APPLICATION FOR PERMISSION

For Official Use Only 請勿填寫此欄	Application No. 申請編號	A/YL/330
	Date Received 收到日期	2025 -07- 2 9

Comments and Responses for Drainage Department (Lot 764RP DD 120)

Project:	Temporary Shop and Services with Ancillary Office at Lot 764RP	Date	File No: DS02
	in DD120 in Ma Tin Road in Yuen Long, N.T.	19/1/2025	Sheet No.
Title:	Stormwater Drainage Proposal		1 of 3

Full-bore capacity of the proposed precast concrete pipe section

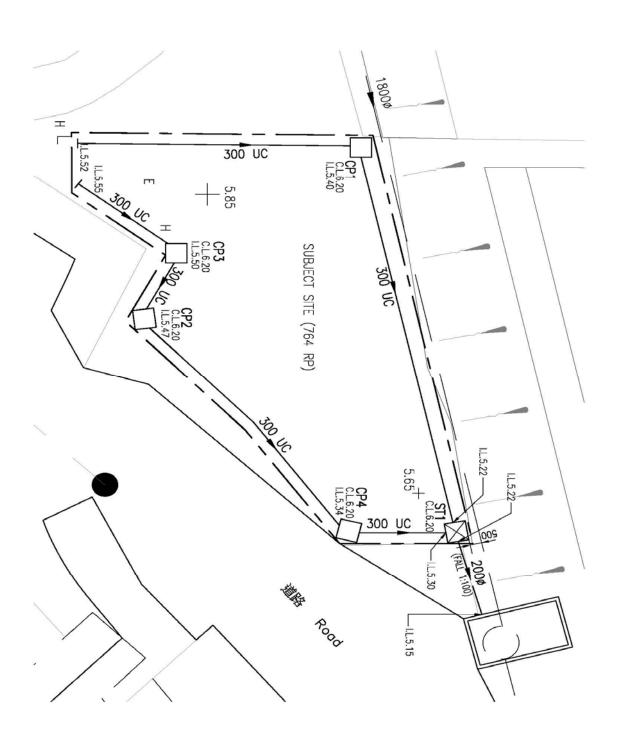
II. Please justify the size of the 200mm underground pipe with hydraulic assessment while it conveys the flow of two 300 UC upstream.

Please refer to the attached hydraulic calculation

```
Pipe Width =
                                200
                                                       0.2
                                                             m
                                       mm
            Pipe Depth =
                                                       0.2
                                200
Hydraulic Gradient, S<sub>f</sub> =
                               0.01
          Gradient 1 in =
                                100
                               0.04 \text{ m}^2
                               0.6 m
                      R = 0.0667 \text{ m}
    Full bore capacity = 0.047 \text{ m}^3/\text{s}
```

The capacity (0.047 m³/s) of the proposed pipe is larger than the highest capacity of Return Period 1 in 50 (0.03 m³/s). Therefore, used 200mm precast concrete pipe is adequate for catchment Area of A.

Plan of Catchment Areas NTS

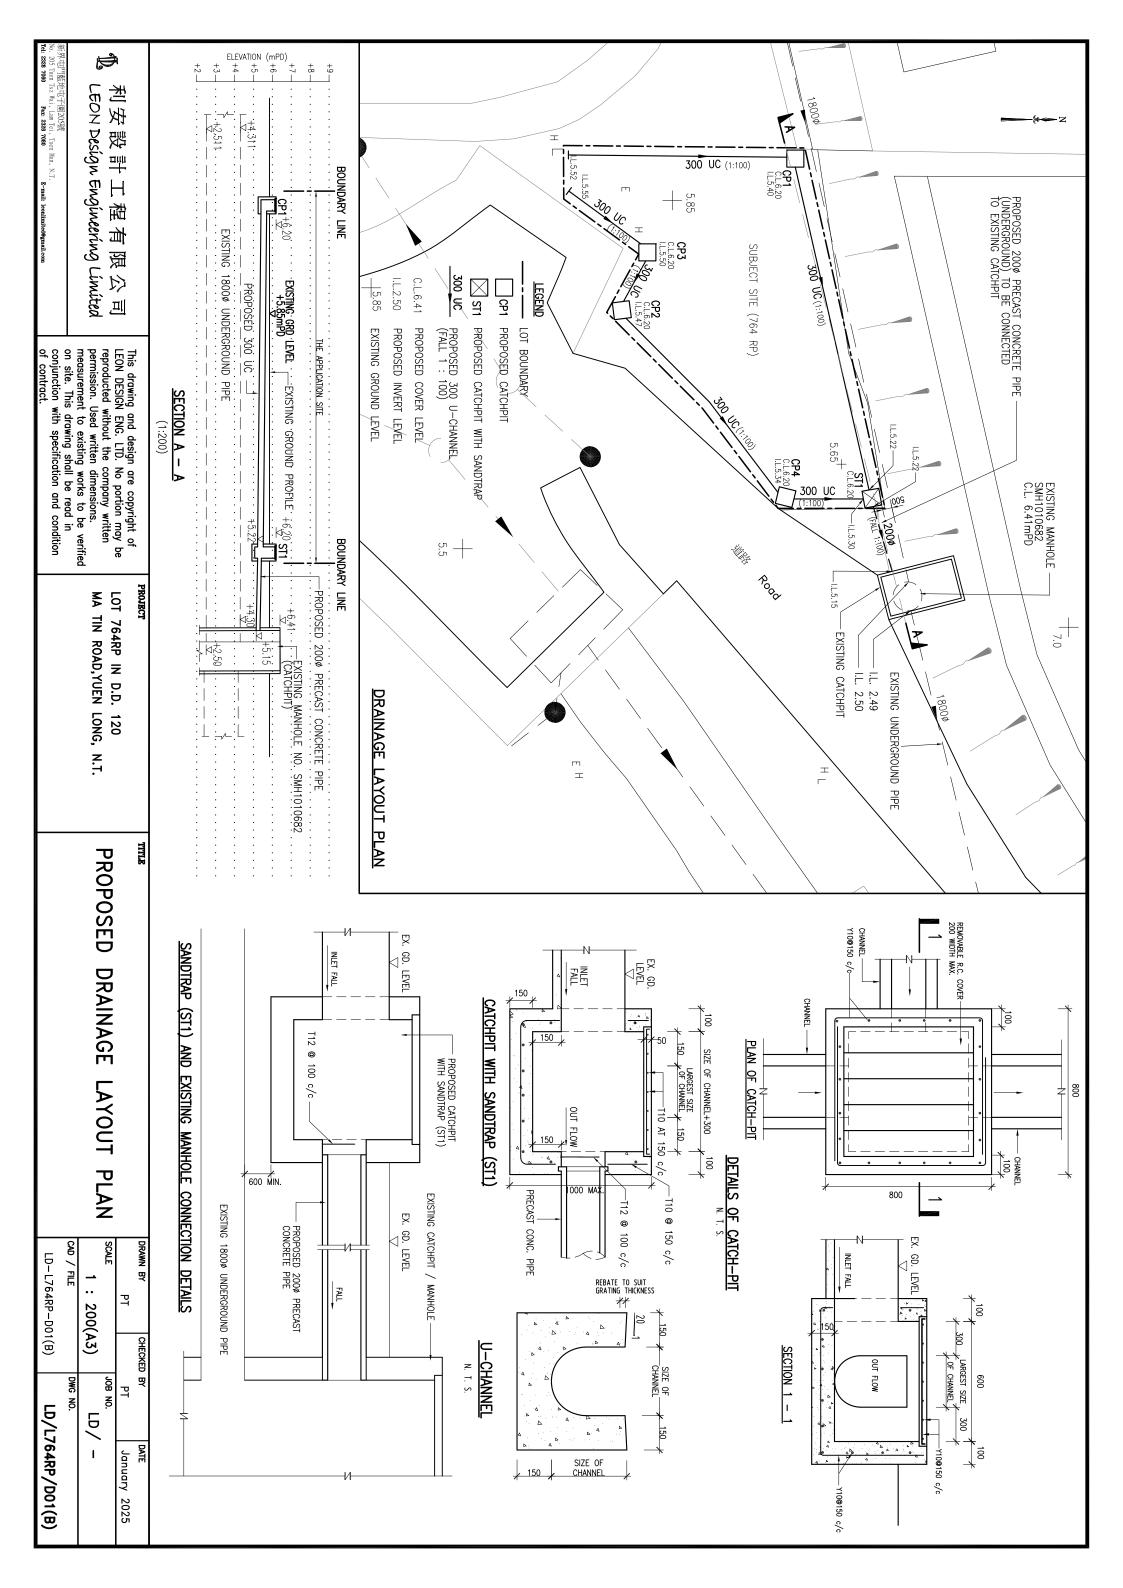
Section A-A; please advise the clearance provided between a) the proposed catchpit with sand trap and the existing 1800mm underground pipe and b) the proposed 200mm pipe and the existing 1800mm underground pipe for review. Please also review the alignment of the proposed 300mm u-channel to minimize the conflict with the said existing 1800mm pipe

Please refer to the attached drawing

Project 項目名稱:	Remarks 備註: 申請	地點 【】 私家車	Scale 比例:
丈量約份第120 約地段第764 號餘段(部分) 及毗鄰政府土地	車位	>>>>>>> 車輛路徑線	
	Drawing Title 圖紙標題: 私家車行駛路線圖	Drawing No 圖紙號 : 圖B	FiBi International Project Consultancy Co. Limited

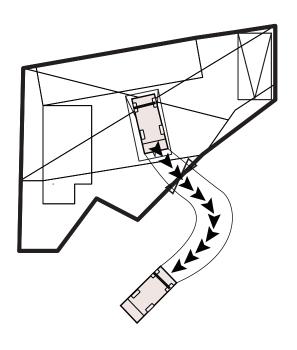
- The vehicular access point is not the at the 3.8m access. Please clarify.
- 2. The 3.8m access is insufficient according to the swept path below, please clarify.
- 1. 場地有2個車位。
- 2. 圖錯了已更改(P.2),3.8公尺是夠的,申請地點外有足夠位置。
